# 1.0 INTRODUCTION

This document, along with the edited version<sup>1</sup> of 2011 2<sup>nd</sup> Revised Draft Environmental Impact Report (2011 2<sup>nd</sup> Revised Draft EIR or 2011 2<sup>nd</sup> RDEIR), represents the Final Environmental Impact Report (Final EIR) for the Consideration of Modifications to the U.S. Bureau of Reclamation's (Reclamation) Water Rights Permits 11308 and 11310 (Applications 11331 and 11332) to Protect Public Trust Values and downstream Water Rights on the Santa Ynez River below Bradbury Dam (Cachuma Reservoir) (hereafter referred to as the "proposed project"). It has been prepared in accordance with the California Environmental Quality Act (CEQA) (Public Resources Code Section 21000 et seq.), and its implementing guidelines (California Code Regulations, title 14, Section 15000 et seq., [*State CEQA Guidelines*]) as amended.

**Re: Palmer Gavit Jackson Trust Comments to Second Revised Draft EIR Prepared for and Relating to the Modifications of the U.S. Bureau of Reclamation's Water Right Permits 11308 and 11310 (Applications 11331 and 11332) regarding the Cachuma Project on the Santa Ynez River**

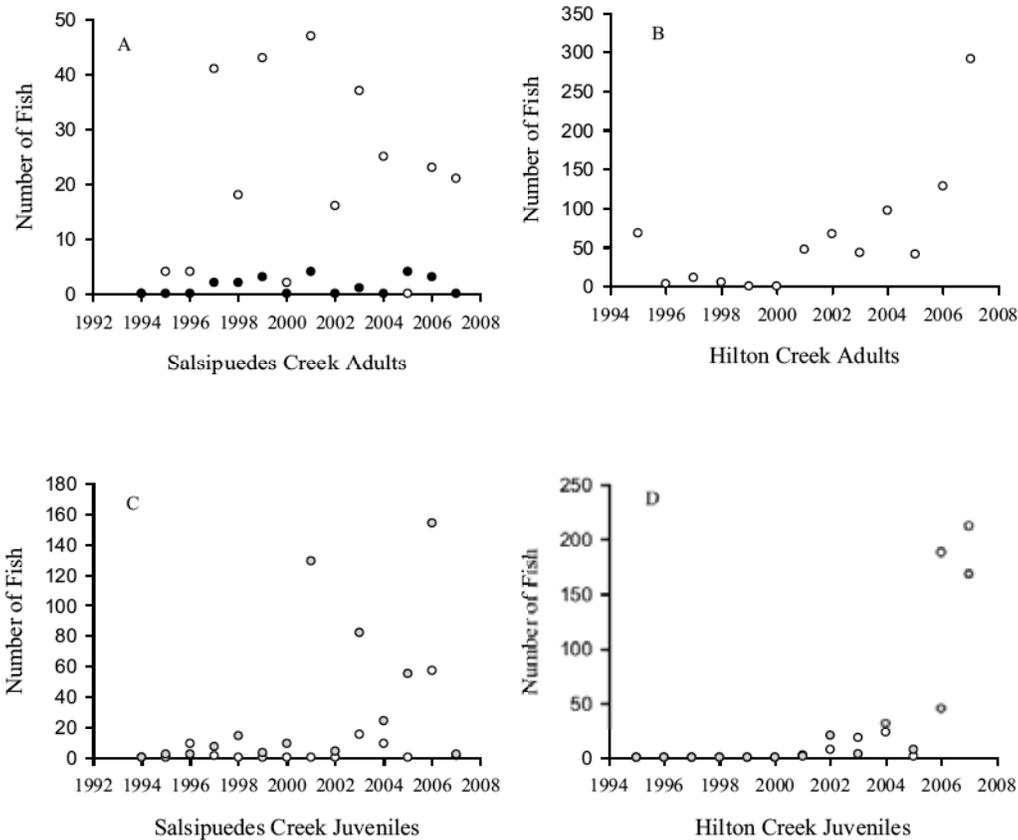
Robinson et al. (2007) also report data from traps in Hilton Creek and Salsipuedes Creek (Figure 9). High flows and other problems can interfere with trapping, but the data show that pumping water from Lake Cachuma into Hilton Creek, which began in 2000 has been helpful. Nevertheless, since the efficiency of the traps is reported to be high, the data indicate that the number of fish in these creeks is small. As noted below, it is also apparent that predominantly resident or hatchery fish are using the improved conditions in Hilton Creek.

The available data on the size of the anadromous fraction of the Santa Ynez population (e.g., Figure 9) are not encouraging. For example, it appears that the spawning fish taking advantage of improved conditions in Hilton Creek are resident rather than anadromous (Figure 9B), and no more than four anadromous adults have been captured in Salsipuedes Creek in any recent year (Figure 9A). It is not even clear that the anadromous fraction of the run is self-sustaining, and by comparison to historical runs, even those remaining after a large fraction of the upper watershed had been blocked by dams (Good et al. 2005), the existing anadromous run barely exists at all. This suggests that conditions below Bradbury Dam may be selecting against the anadromous life history pattern, in an evolutionary sense. Thus, considerations regarding both life history diversity and spatial distribution indicate that passage around Bradbury Dam will be necessary to restore a viable population of steelhead in the Santa Ynez River (NMFS 2007b: 36).
